**MIDDLETON CITY PLANNING AND ZONING
COMMISSION MINUTES
FEBRUARY 14, 2022**

3. **Public Hearing: Application by Wade Thomas/IAG Capital, LLC, and Bob Unger for preliminary plat with respect to The Mill at Middleton Subdivision located at 0 N. Dewey Avenue (Tax Parcel Nos. R33892, R33888, and R33876). The proposed preliminary plat consists of 50 residential lots and 10 common lots on 16.71 acres of vacant land zoned R-3 (single family residential). – Roberta Stewart**

The Mill at Middleton Subdivision
Preliminary Plat Application - Middleton Planning & Zoning Commission
Public Hearing February 14, 2022

Initial Planner Comments The Mill Subdivision (Pre-Plat dated 6/10/2021) December 16, 2021

PRELIMINARY PLAT SHOWING
 THE MILL AT MIDDLETON SUBDIVISION
 LOCATED IN THE SE 1/4, OF
 SECTION 6, T.4N., R.2W., B.M.
 CANYON COUNTY, IDAHO
 2022

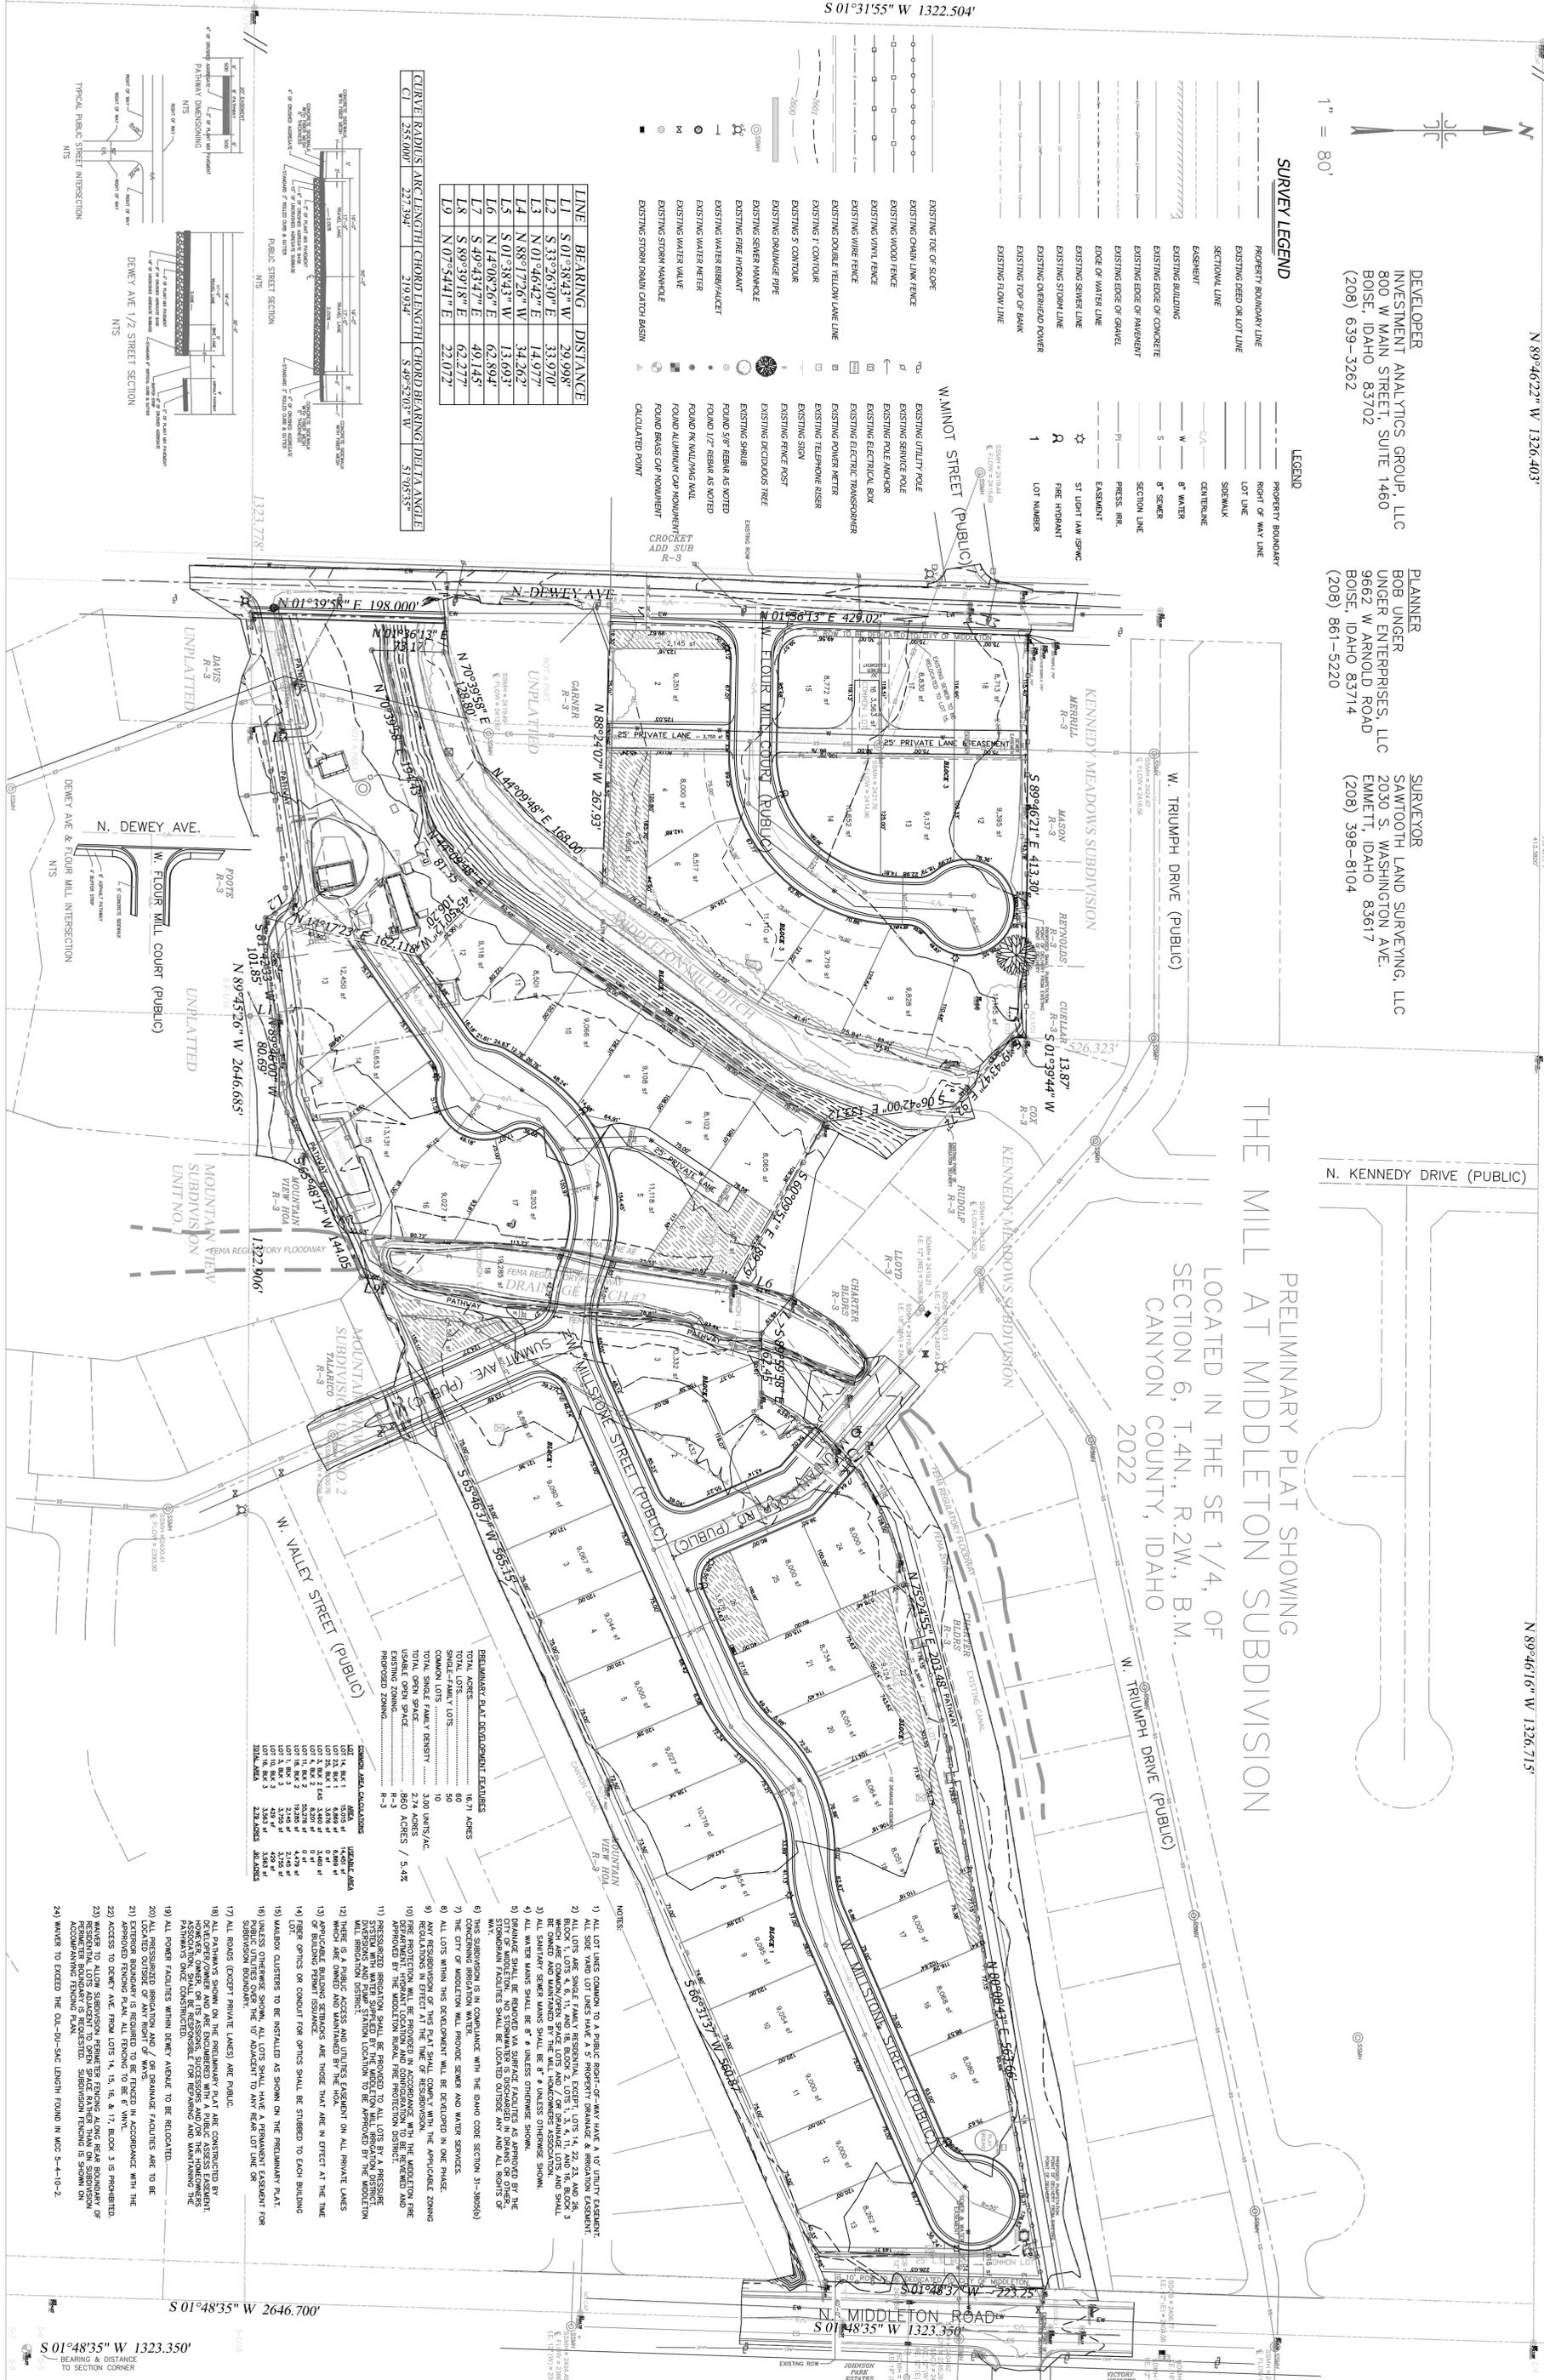
MCC 5-4-4.2. a. Please add bearing and distance to section corner, quarter corner or monument of record.

MCC 5-4-4.2. f. Revise topography to clearly show existing.

1. Either eliminate lines (assumed existing) or label.
2. Dimension and clearly identify every lot.
3. Please use 2ft contours and label them.
4. Add benchmark information.

1. Show Canyon Canal along the south boundary, including topography.
2. Show existing irrigation infrastructure for parcels and relocation if applicable.

1. Dimension existing rights of way and clearly label/name.
2. Show improvements on Dewey clearly and how proposed frontage area will transition to existing. Include stormwater management.
3. Dimension right of way for Dewey.
4. Show existing easements including for "Existing Canal Drainage Ditch #2" and Middleton Mill.
5. Add note or callout power in Dewey to be relocated.
6. Show Minot Street intersection and label.
7. Mountain Loop Road (not legible) right of way to be consistent to the intersection with Millstone Drive.
8. Is the sewer easement 30ft or 20ft? Show the easement.
9. Label Middleton Road right of way and additional width to be dedicated.

10. What is the ownership of the private lanes? If separate lot, label accordingly. If easement area then also dimension and clarify.

1. Add a note addressing installation of fiber optic network.
2. Add note hydrant location and configuration to be reviewed and approved by Middleton Rural Fire Protection District.

1. Review the sewer crossing at Summit (profile) and verify there is sufficient depth and separation from the bottom of the canal per the irrigation or drainage district with jurisdiction.
2. What is the purpose of new 20ft sewer easement between lot 16 and lot 14, block 3.

3. Water corridor is north and east, sewer is south and west.
4. Please plan to connect to the existing water main at the intersection of Middleton Road, at Summit and at Mountain Loop.
5. Connect to Middleton water main at 90d and add three valves.
6. Show the existing water in all streets and in private lanes. How will utilities be extended to lots and is there separation per IDAPA?

1. Stormwater. Plan to manage a 100 year/1 hour storm using retention facilities only. No subsurface. The front half of the lot C value is 0.60, the rights of way/impervious (all) are 0.95 – use a composite of both. All stormwater management facilities require pretreatment, all infrastructure to be shown on preliminary plat. Stormwater facilities are owned by HOA and the provisions for maintenance laid out in CCRs. Identify lots to be used for stormwater management
2. Note 5. No discharge of stormwater from rights of way.

Add note detailing all irrigation and/or drainage to be relocated out of rights of way.

Note 6. Expand to address Idaho Code 31-3805(b). Show the irrigation system layout and point of diversion/pump station location. Combine with Note 11.

Note 7. City of Middleton will provide sewer and water service.

Note 8. Delete

Note 12. Add public utility to the easement purpose.

Note 19 and Note 20. Delete.

Add a note regarding fiber.

Add a note: exterior boundary is required to be fenced in accordance with approved fencing plan. Remove perimeter fence callout or add it to the landscape plan.

Correct street names. Street is east/west. Avenue is north/south. Cul-de-sac is Court.

Add centerline radii and intersection radii.

MCC 5-4-4.2. a. Please add bearing and distance to section corner, quarter corner or monument of record.

MCC 5-4-4.2. f. Revise topography to clearly show existing.

1. Either eliminate lines (assumed existing) or label. Dewey/Middleton and local streets.
2. Dimension and clearly identify every lot. Make dimensions larger. They are not legible.
3. Please use 2ft contours and label them. Labels are not legible.
4. Add benchmark information.

1. Show Canyon Canal along the south boundary, including topography.
2. Show existing irrigation infrastructure for parcels and relocation if applicable.

1. Dimension existing rights of way and clearly label/name. Middleton Highway District does not exist. City of Middleton only.
2. Show improvements on Dewey clearly and how proposed frontage area will transition to existing. Include stormwater management. Add a typical section.
3. Dimension right of way for Dewey.
4. Show Minot Street intersection and label. Label all existing streets on the plat.
5. Mountain Loop Road right of way to be consistent width to the intersection with Millstone Drive.
6. Show the sewer easement per the record. The sewer easement near the north boundary of Lot 11 Block 3 is not approvable as shown. The east limits are too narrow.
7. Label Middleton Road right of way and additional width to be dedicated. Middleton Highway District does not exist. City of Middleton only.
8. Text is not legible on private lanes.

1. Review the sewer crossing at Summit (profile) and verify there is sufficient depth and separation from the bottom of the canal per the irrigation or drainage district with jurisdiction and the City. **You need to submit bottom of ditch elevation and top pipe elevation and verify the sewer can be installed as shown.**
2. Also evaluate Drainage Ditch 2 the same way.
3. For the sewer relocation: the sewer easement is not approvable as shown. Need at least 10ft min on offside.

4. Water corridor is north and east, sewer is south and west. Review IDAPA and revise linework to provide at least 10ft of separation between water and sewer. Water and sewer are in roadway, not under curb/gutter.
5. Connect to Middleton water main at 90d and add three valves.
6. Clearly show existing water in Dewey and new water in culdesac. Add valves.
7. Three valves at tee, four valves at cross, typical of all.
8. Label existing water and show where existing connects to new.

1. **Stormwater. Submit preliminary stormwater management calculations and design.** Plan to manage a 100 year/1 hour storm using retention facilities only. No subsurface. The front half of the lot C value is 0.60, the rights of way/impervious (all) are 0.95 – use a composite of both. All stormwater management facilities require pretreatment, all infrastructure to be shown on preliminary plat. Stormwater facilities are owned by HOA and the provisions for maintenance laid out in CCRs. Identify lots to be used for stormwater management
2. Note 5 - revise. No discharge of stormwater. **No stormwater is discharged into drains or other.**

Note 6. Expand to address Idaho Code 31-3805(b). Show the irrigation system layout and point of diversion/pump station location. Combine with Note 11. It is not clear what is happening with irrigation for west culdesac. Is lot 10 a pumpstation lot? Where is point of diversion/overflow, etc? Pump stations can be highly problematic when constructed this close to homes because of noise.

Correct street names. Street is east/west. Avenue is north/south. Cul-de-sac is Court.

Add centerline radii and intersection radii.

Enlarge typical section for local roads. Very difficult to read. Add typical section for Dewey.

MCC 5-4-4.2. a. The boundary submitted cannot be used to verify ownership or other descriptions as required. Please add bearing and distance to section corner, quarter corner and monuments of record. The boundary on the preliminary plat doesn't match the "Boundary and Topographic Survey" submitted separately.

MCC 5-4-4.2. f. Revise topography to clearly show existing.

1. Either eliminate lines (assumed existing) or label. Prefer delete. Dewey is not legible. Middleton is very hard to read but not as important because it is improved.
2. Dimension and clearly identify every lot. Dimensions are not legible – they are too small and lot numbers obscured.
3. Please use 2ft contours and label them. Labels are not legible – too small and obscured by lines through them.
4. Add benchmark information.
5. The "Boundary and Topographic Survey", stamp Joe Jones, PLS, 02.07.2022: contour labels not legible.

1. Dimension existing rights of way and clearly label/name. Dewey is not legible. The right of way shown on the plat does not match the ownership line on the boundary submitted separately.
2. Show improvements on Dewey clearly and how proposed frontage area will transition to existing. Include stormwater management. Add a typical section. The typical section is not legible. Is the 30ft dimension from centerline or section line? Are centerline and section line coincident?
3. Dimension right of way for Dewey. Not legible.
4. Mountain Loop Road right of way dimension is not legible.

2. Verify adequate slope to relocate the existing sewer as shown on Lot 16 Block 3, assume 0.1' drop through two new manholes. Correct the note.

3. Water and sewer are in roadway, not under curb/gutter. Add a note: water and sewer shown schematically. Final alignment determined at final design and per city requirements. Line work may be revised if you don't want to add a note.
4. Label existing water and show where existing connects to new. Add call out: connect to existing water. Not legible in Mountain Loop or Summit.

2. All stormwater management facilities are retention facilities and require pretreatment. Show pretreatment on preliminary plat. The stormwater management system must be in conformance with the ISPWC, the City of Middleton Supplemental and DEQ best management practices.

3. Delete SITE DRAINAGE DESIGN CONCEPT, upper right corner. All stormwater requires pretreatment, concrete V ditches are not approvable for conveyance, and drainage easements for swales developed on building lots will not be approved. If you wish to develop grassy swales for pretreatment, swales will need to be located in common lots and completely accessible for maintenance. Valley gutter may be used to convey stormwater across the street. Infiltration basin with forebay may be approved on case by case basis and if a retention facility cannot be utilized.

4. Preliminary Drainage Calculations – stamp Cory Schrack PE, no date. Document dated February 4, 2022. Please do not assume pre-existing stormwater flow is offset, as presented in the stormwater calculation. Do not need to revise calculations at this time - can be revised in final design. The Storm Drainage Design Concept is not approvable, per comment 2 above. Please evaluate the drainage basins per comment 1 (above) and submit a simple preliminary design that shows the areas proposed are adequate for retention and identify location and type of pretreatment to be developed.

Per Middleton Rural Fire - dead end lanes/roads that are more than 150 ft to the structure are required to have a fire approved turn around. The belly/turn around configuration on Millstone may be required to move west. Lot 7 Block 2 is in question. Please follow up specifically with Middleton Rural Fire and adjust the plat if required.

Clearly show the ingress/egress easement along south boundary.

2nd Round Planner Comments The Mill Subdivision (Pre-Plat dated 12/29/2021) January 5, 2022

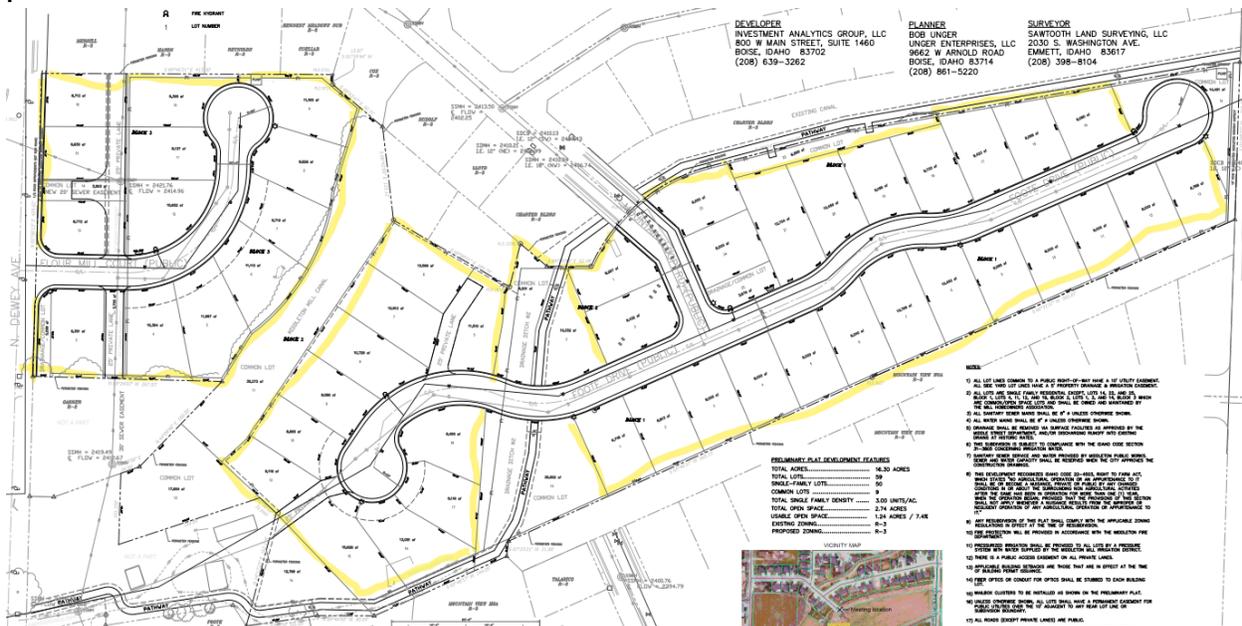
1. City will take care of 2 non-conforming lots to the north, and it is no longer a problem for this development.
2. Talk with HOA that owns Summit Road section over Canal to determine best way to get road completed over Canal.

3. Add a lot and block designation to the common lot south of Foote Drive where the Drainage Ditch #2 is located. It probably should be Lot 19/Block 2. Then change the other Lot 19/Block 2 to Lot 20/Block 2.

4. Change the name of Foote Drive to another name not on the County's road list. Foote Avenue already exists.
5. Middleton Road requires a 24' landscape buffer "easement" along the frontage per 5-4-10-4. Just call out the easement and show it on the Landscape plan.

3rd Round Planner Comments The Mill Subdivision (Pre-Plat dated 1/5/2022) January 12, 2022

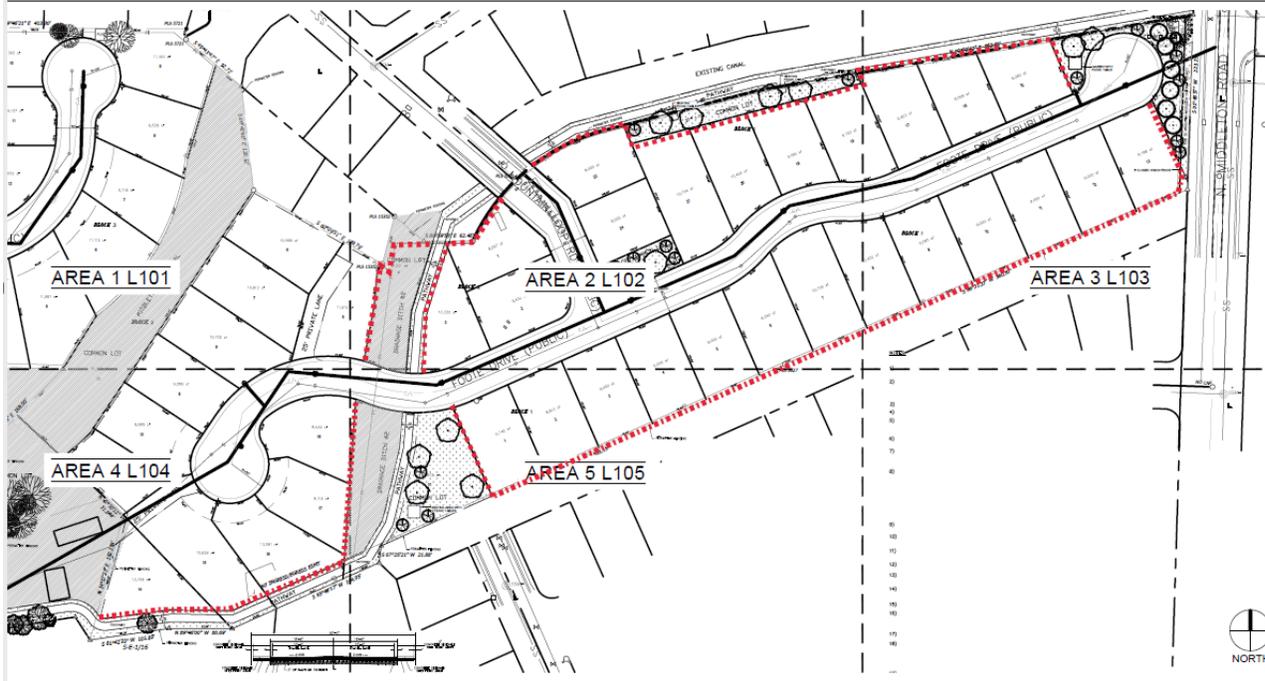
1. Amy W., noted that you need a variance for the cul-de-sac length exceeding 600'. We are allowed to handle variances as "waivers" to the code during the pre-plat process (MCC 1-15-2), and you will not need to physically submit a variance. BUT, please add a note to the Preliminary Plat that there is a variance to exceed the cul-de-sac length found in MCC 5-4-10-2.
2. Please change note 12 to add language that all Private Lanes are owned and maintained by the HOA. .
3. As Amy requested, please remove the perimeter fence call-outs from the pre-plat, but we need you to show the fencing on the landscape plan. Also, add a note to the preliminary plat as follows:

"Variance to allow subdivision perimeter fencing along rear boundary of residential lots adjacent to open space rather than on subdivision perimeter boundary. Subdivision fencing shown on accompanying Landscape Plan."

Please do not put the perimeter fencing on all of the subdivision perimeter boundary because it will unnaturally enclose open space/common lots. Please show "perimeter" fencing around common lots as shown below. Except you might prefer to fence in the canal for safety reasons. If you do, please consider wrought iron fencing along the canal so the pathway seems open, walkers can enjoy seeing the water, but children will not be endangered. Site plan below generally shows that wherever common open space is present, the fencing should end at the boundary of adjacent residential lots and not enclose the common area.
